# Chapter 5

## 5.0 OPERATIONS

**TROJAN ISFSI**  
SAFETY ANALYSIS REPORT

**FIGURE 7.3-2**  
SUMMARY OF DOSE RATES FOR  
CONCRETE CASK (PWR)

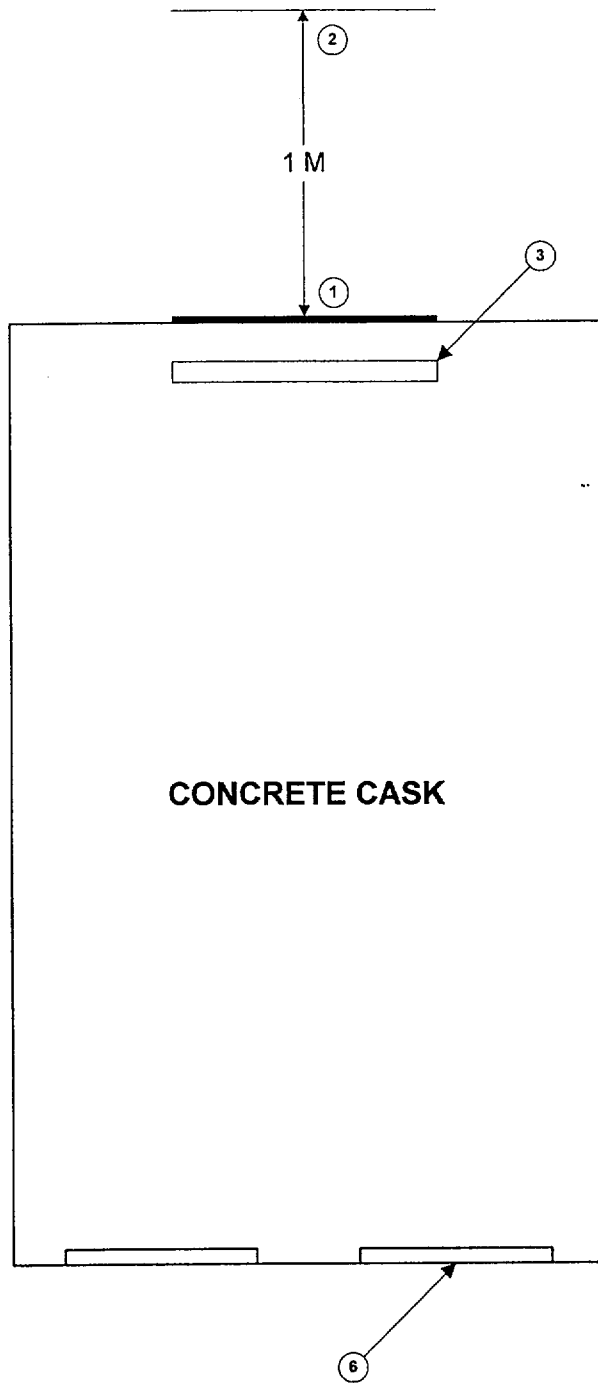
LOCATION	DOSE RATE (mrem/hr)
1	<del>158.5</del> 275.3
2	<del>133.9</del> 111.1
3	<del>6.76</del> 38.7
4	<del>49.4</del> 13.7
5	<del>10.2</del> 6.5
6	<del>18.77</del> 3.9
